Questionnaire 4

Request for renewal of exemption 27 of RoHS Annex IV, “Lead in solders, termination coatings of electrical and electronic components and printed circuit boards, connections of electrical wires, shields and enclosed connectors, which are used in-magnetic fields within the sphere of 1 m radius around the isocentre of the magnet in medical magnetic resonance imaging equipment“, for 7 years

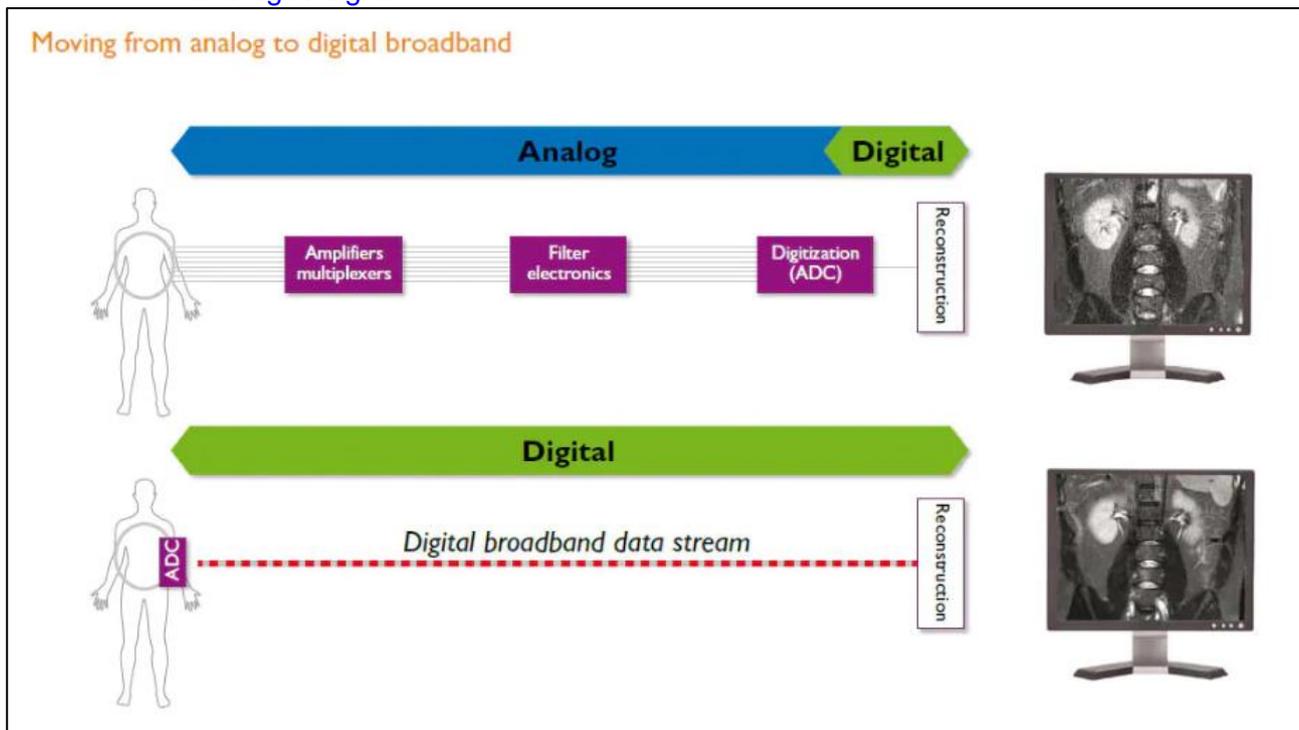
2. You mention digital coils in your answers to the previous questionnaire stating that digital coils would not need exemption 27 either.
 - a. Could you kindly give us some insights into the differences between the current lead-containing, the newly designed lead-free coils, and the digital coils?

Digital coils have performance advantages over analogue and so many of the recently developed coils for new types of MRI are digital. Originally, since about 2010, these were designed using lead-based solders as the reliability of lead-free designs could not be ensured. Recently new designs of analogue and digital coils are being developed with lead-free solders and as older models of MRI are phased out and replaced, the proportion of coils made using lead-free solders will gradually increase, as shown in the hypothetical graph below (note that COCIR does not have actual data as this is proprietary to individual manufacturers).

A few types of coil may always be analogue (see previous question). The timescale to replace lead will be at least 15 years for both analogue and digital coils as shown in the graph in answer to Q2a. We can expect that for at least 10-15 years there will still be the need to deliver lead-soldered analogue coils for use with installed MRIs as well as spare parts. Unfortunately, additionally supplied coils do not fit the definition of spare parts (which need to be replacements) that was defined keeping in mind domestic appliances and ICT. This exemption would not be necessary if the definition of spare parts is revised for medical imaging devices (and probably for capital investment equipment in general).
